Access Compliance Report

Public Rights-of-Way

(Curb Ramps)

Intersection ID: 27772	Main Street: BRIARWICK_LN	Cross Street: NORTH_COMMUNITY_HOUSE_RD	Location: NW
ADA ID: 830B00A296C3	Ramp Type: Perp	Initial Pass/Fail: Fail	Overall Compliance: No
Severity Score: 22.5			
Codes/Mitigation Info/Possible Solution		Field Measurements/Component Compliance

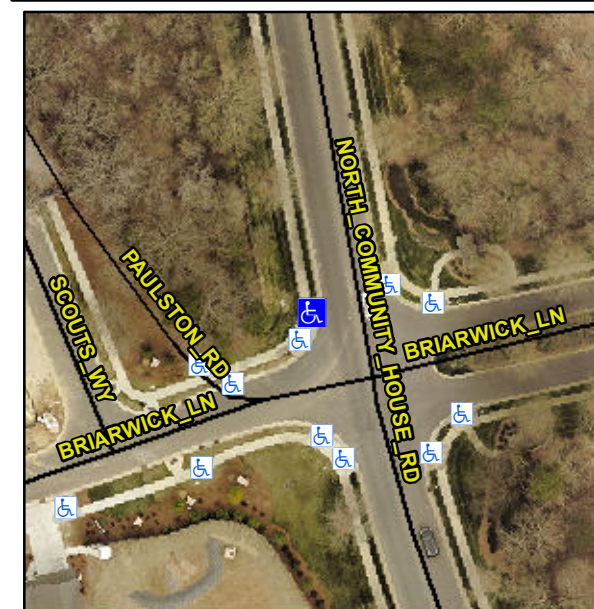
Not Found, R304.5.1, R304.2.2, R304.5.3

Compliance	Description	Data	Compliance	Description	Data
N/A	Ramp Length (in)	103.0	No	Ramp Slope (%)	9.3
No	Ramp Width (in)	40.0	No	Ramp XSlope (%)	4.5
N/A	Flare Type LT	N/A	N/A	Flare Type RT	N/A
N/A	Flare Slope LT (%)	N/A	N/A	Flare Slope RT (%)	N/A
N/A	Flare Traversable LT?	N/A	N/A	Flare Traversable RT?	N/A
N/A	Landing Length (in)	N/A	N/A	DWS Provided?	N/A
N/A	Landing Width (in)	N/A	N/A	DWS Contrast?	N/A
N/A	Landing Slope (%)	N/A	N/A	DWS Length (in)	N/A
N/A	Landing X Slope (%)	N/A	N/A	DWS Full Width?	N/A
N/A	Landing Curb? (Y/N)	N/A	N/A	DWS Offset (in)	N/A
N/A	Shared Landing?	N/A			
N/A	Gutter Ponding?	N/A	N/A	Gutter Slope (%)	N/A
N/A	Gutter Lip Ht (in)	N/A	N/A	Gutter X Slope (%)	N/A
N/A	Painted X Walk1?	No	N/A	Painted X Walk2?	N/A
	X Walk 1 Direction	To NE		X Walk 2 Direction	N/A
N/A	X Walk 1 Width (in)	N/A	N/A	X Walk 2 Width (in)	N/A
	X Walk 1 Slope (%)	5.3		X Walk 2 Slope (%)	N/A
	X Walk 1 X Slope (%)	3.7		X Walk 2 X Slope (%)	N/A

Remove & Replace Entire Ramp.
